MODIFICATION RECOMMENDED

N5221A-02

N5221A PNA Series Microwave Network Analyzers

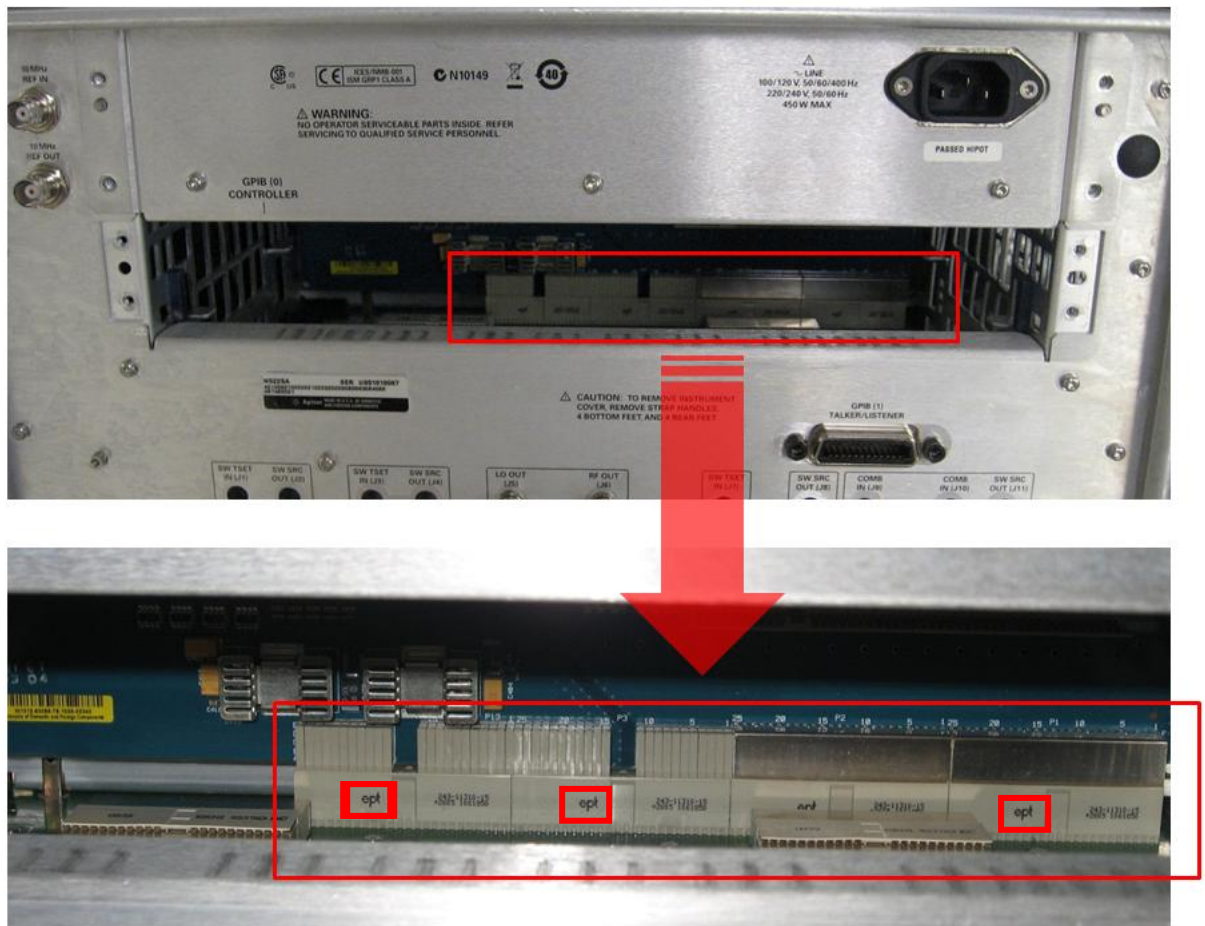
1. Remove the CPU assembly from the analyzer's rear panel. Refer to the PNA Service Guide chapter 7 section titled, "Removing and Replacing the CPU Board Assembly" for removal and reinstallation procedures. To view the online Service Guide, see the numbered list on the next page for instructions.
2. As per the photo below, inspect the system motherboard connector to see if it has one or more "ept" logos.

3. If the connector has one or more “ept” logos, return the analyzer to Agilent for replacement of the system motherboard. If the connector does not have one or more “ept” logos, email support_ctd-soco_support@agilent.com, providing the analyzer model and serial number and details of the malfunction symptoms.

4. *For Agilent Service Technicians only:* Only new boards without “ept” logos should be installed. Before installing the new board, look to see if it has one or more “ept” logos. If so, email support_ctd-soco_support@agilent.com, providing the analyzer model and serial number. Wait for further instructions in an email reply. New boards without “ept” logos can be installed.
For installation instructions, refer to the PNA Service Guide chapter 7 section titled, “Removing and Replacing the System Motherboard.” To view the online Service Guide, see the numbered list on the next page for instructions.
